## Product Change Notice (PCN)

**PCN Number:** PCN-0451320R-01

**Product(s) Affected:** PDP-30

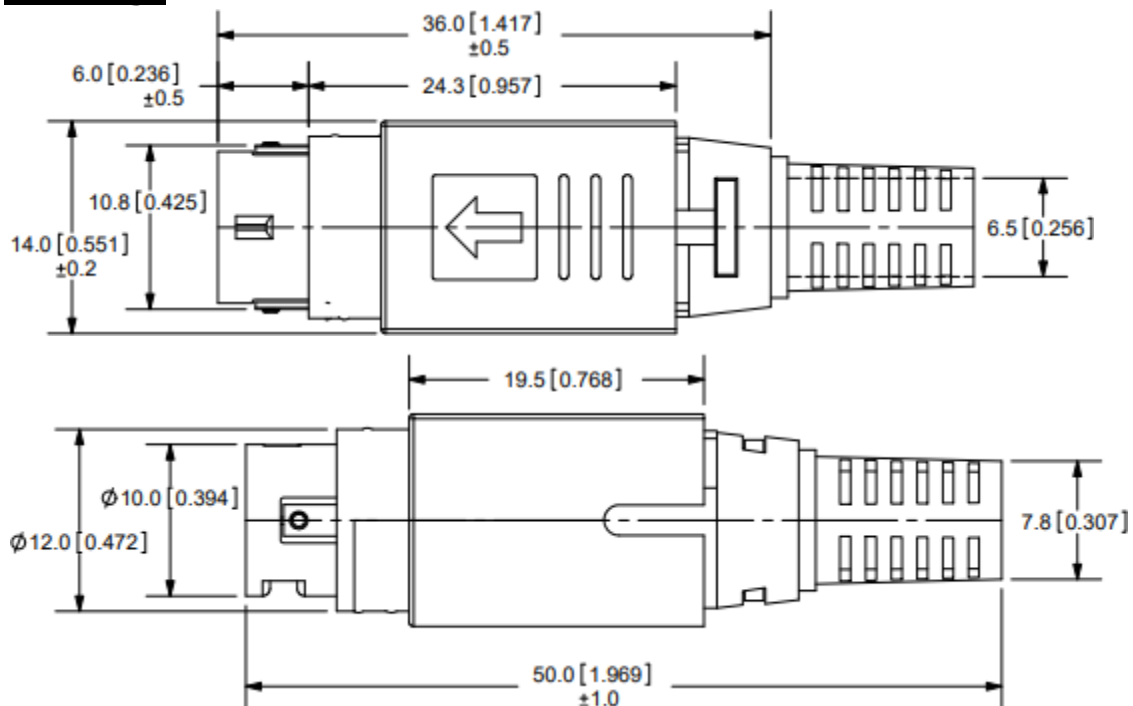
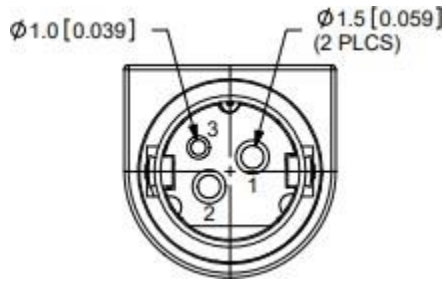
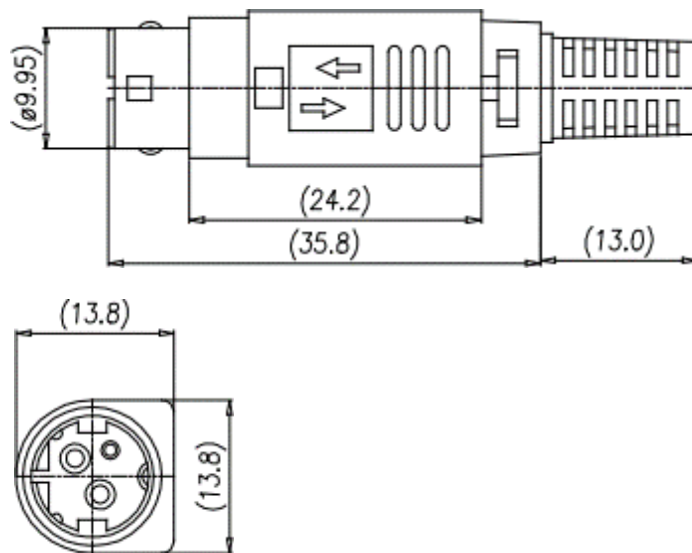
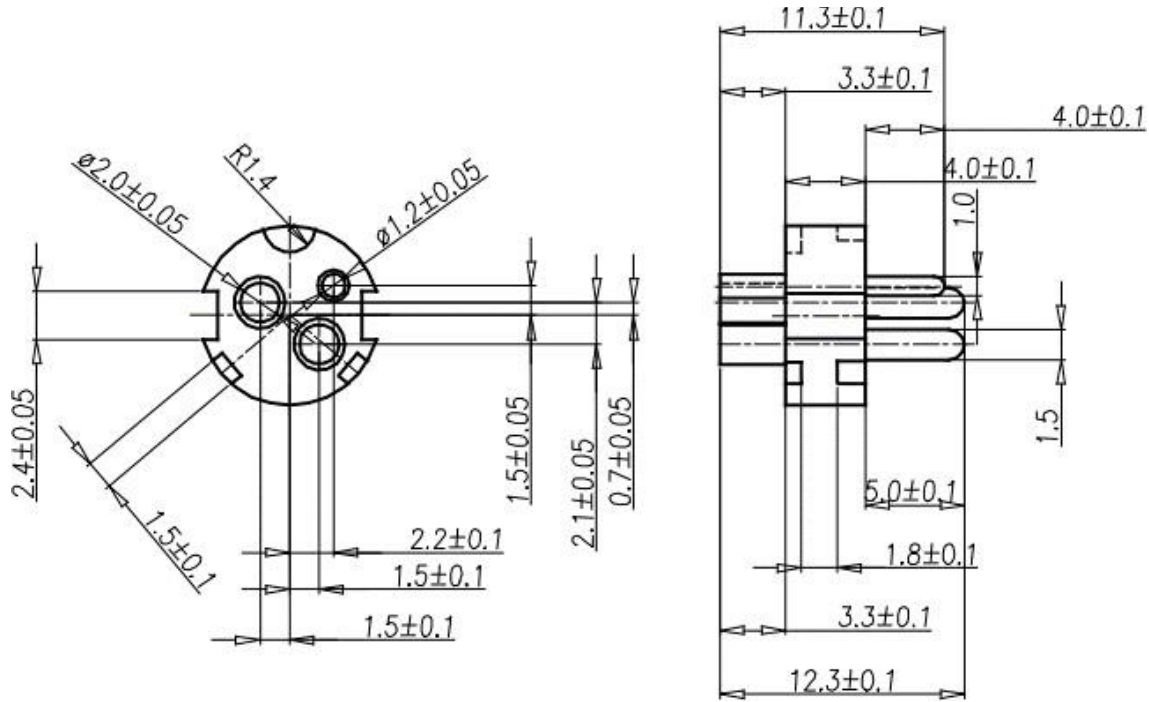
**Reason(s) for Change:** manufacturing build location change.

**Description of Change:** housing and materials changes as shown below.

## Old design materials

MATERIAL	PLATING
OUTER HOOD	ABS	
METAL SLEEVE	Brass	Nickel
CLAMP	Brass	Nickel
PIN/BODY	Brass/PBT	Silver
PLASTIC RING	POM	
METAL COVER	Brass	Nickel
SPRING	Steel	
INNER HOOD	ABS	
STRAIN RELIEF	PVC

## New design materials

MATERIAL	PLATING
housing	PBT (UL94V-0)	
contacts	copper alloy	silver
plastic cover	ABS	
metal shell	copper alloy	nickel
metal cap	copper alloy	nickel
cable fixer	copper alloy	tin
ring	POM	
spring	steel	nickel
plastic tube	ABS	
SR	PVC
